**PCN#20191212001.1B
New Tray for Select Devices
Final Change Notification**

Date: April 27, 2020
To: Newark/Farnell PCN

PCN Number:	20191212001.1B	PCN Date:	April 27 2020
Title:	New Tray for Select Devices		
Customer Contact:	PCN Manager	Dept:	Quality Services
Proposed 1st Ship Date:	Oct 11 2020		
Change Type:			
<input type="checkbox"/>	Assembly Site	<input type="checkbox"/>	Assembly Process
<input type="checkbox"/>	Design	<input type="checkbox"/>	Electrical Specification
<input type="checkbox"/>	Test Site	<input checked="" type="checkbox"/>	Packing/Shipping/Labeling
<input type="checkbox"/>	Wafer Bump Site	<input type="checkbox"/>	Wafer Bump Material
<input type="checkbox"/>	Wafer Fab Site	<input type="checkbox"/>	Wafer Fab Materials
		<input type="checkbox"/>	Part number change
		<input type="checkbox"/>	Assembly Materials
		<input type="checkbox"/>	Mechanical Specification
		<input type="checkbox"/>	Test Process
		<input type="checkbox"/>	Wafer Bump Process
		<input type="checkbox"/>	Wafer Fab Process

Tray Comparison Tables:

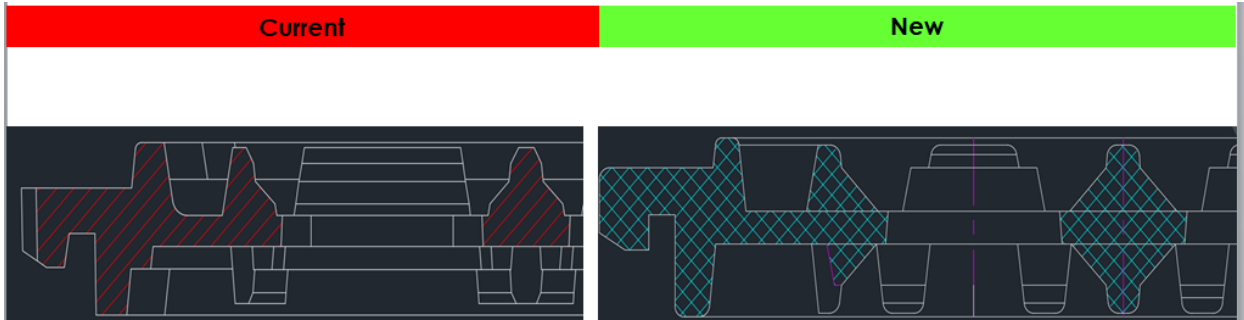
Group 1 Change Description - 14 x 14 TQFP Tray Change:

4223432-0001	4224972-0001
Supplier	UBOT	Peak
Floor design	Circular square	Octagon
Cavity size	16.55 +/- 0.08	16.10 +/- 0.08
Seating ht	1.62 mm (top) 0.75 mm (bottom)	1.5 mm (top) 0.9 mm (bottom)
